Work Order ID 161807***161807***

D3325-041 BASKET LID ASSEMBLY

DRAWING NO. D3325	TITLE BASKET LID ASSEMBLY	REV. B	DART AEROSPACE LTD ENGINEERING ORDER		D.E.O. NO. D3325-B-1	SHEET NO. SHEET 1 OF 1	SCALE NTS
DRAWN AJS	CHECKED <i>[Signature]</i>	MFG. APPR. <i>[Signature]</i>	APPROVED <i>[Signature]</i>		DE APPR. <i>[Signature]</i>		
DATE 08.11.28	DATE 08.11.28	DATE 08.12.01	DATE 08.12.01		DATE 08.12.01

PARTS LIST FOR D3325-041 BASKET LID ASSEMBLY

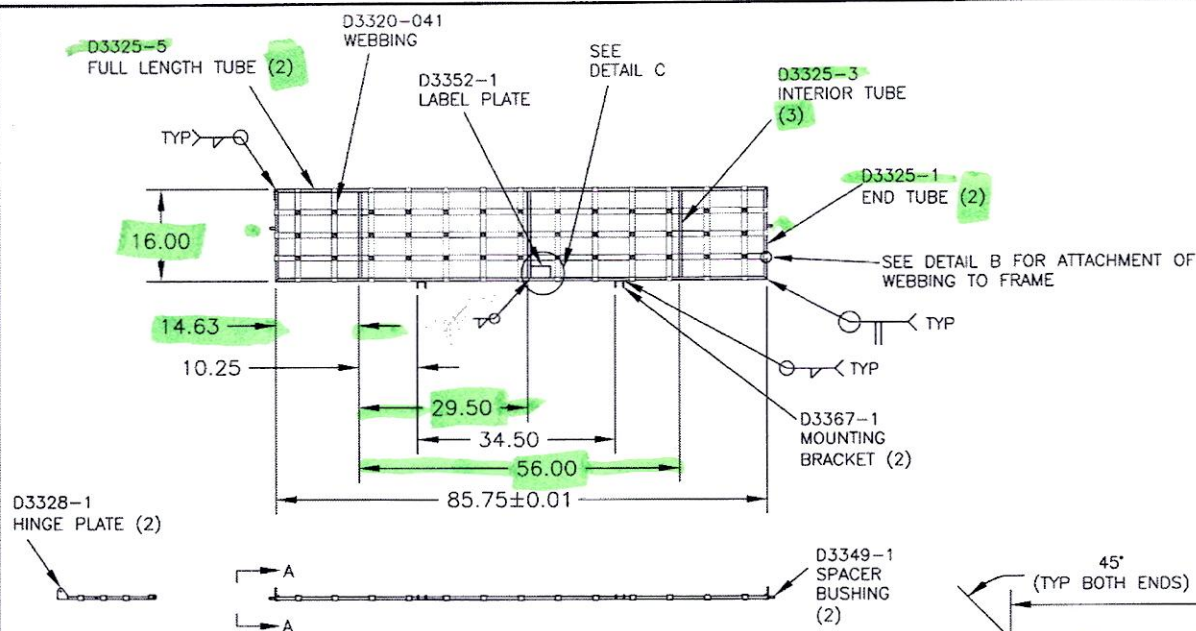
1) SHEET 1 MODIFY PARTS LIST AS SHOWN:

WAS:

MS20600AD4W3	32	RIVET

IS:

MS20600AD4W5	32	RIVET

DETAIL B
TYP. ATTACHMENT OF WEBBING TO LID
FRAME
(SCALE 1:1)

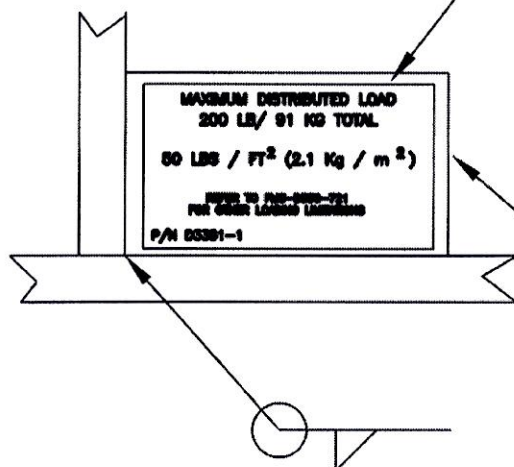
2) UPDATE SHEET 3 DETAIL B ACCORDINGLY.
